In re Application of  
John D. Phillips  
Application No. 10/761,996  
Filed: January 21, 2004  
Attorney Docket No. 25003B

This is a decision on the petition under the unintentional provisions of 37 CFR 1.137(b), filed April 5, 2007, to revive the above-identified application.

MARKED DRAWING  
FOR APPLICATION  
10/761996  
Des. 369,421

FIG. 1

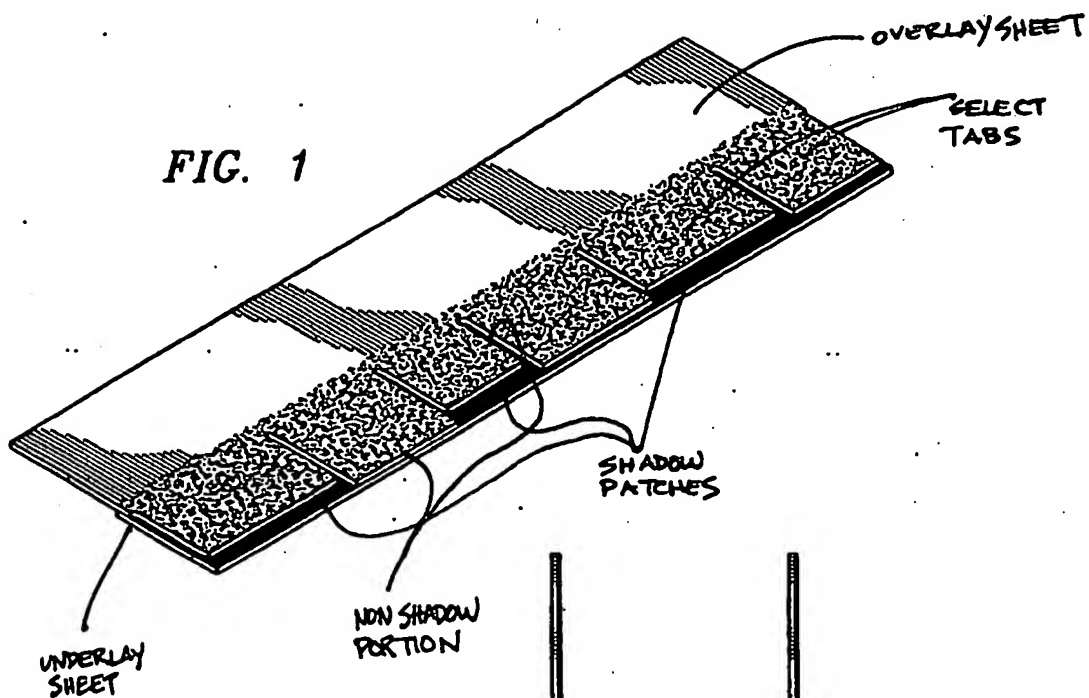
Regarding claims 14 and 18, Kiik discloses a variably (random) cut shingle (see title) having an overlay sheet and underlay sheet (marked fig. 1), each overlay sheet having a plurality of select tabs and the underlay sheets having a plurality of shadow patches (marked fig. 1). Kiik also discloses the tabs as covering portions of the patches (fig. 2). In addition, Kiik discloses a portion which can be construed as a non shadow portion (marked figure) which, together with the shadow patches and remainder portions cause the shingle to appear as varying. However, Kiik does not disclose the underlay sheet as having granules of dark and light color. Phillips discloses a shingle with an

FIG. 2

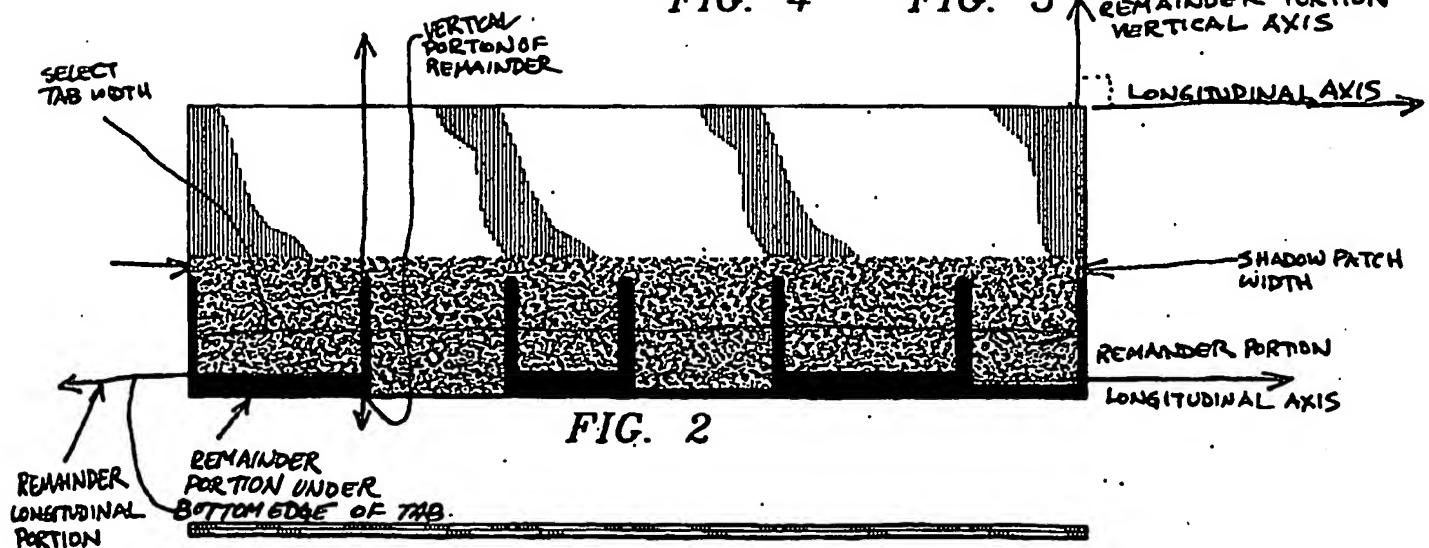
Regarding claim 15, Kiik discloses a remainder portion visible under a bottom edge of a tab (marked fig. 2).

Regarding claim 16, Kiik discloses the shingle as having a longitudinal axis and the remainder portion as having a vertical portion perpendicular to the shingle axis (marked fig. 2).

Regarding claim 17, Kiik discloses the longitudinal axis of the remainder portion as being parallel with the longitudinal axis of the shingle (marked fig. 2).

Regarding claim 19, Kiik discloses a shadow patch width as disposed along the longitudinal width of the shingle (marked fig. 2). Kiik also discloses the shadow width (marked fig. 2) as being longer than the tab width (marked fig. 2). Kiik also discloses the patches and tabs alternating along the length in a synchronized manner (fig. 2).

Regarding claim 20, Kiik discloses the two sheets as laminated together (figs. 3-5) and tabs covering partial portions of patches (fig. 2).

Regarding claim 21, Kiik discloses the remainder portion (marked fig. 2) as being established by the varying lengths of the tabs and patches (marked fig. 2).

Regarding claim 24, Kiik discloses the remainder portion as having a longitudinal portion which is parallel to the shingle longitudinal portion (marked fig. 2).
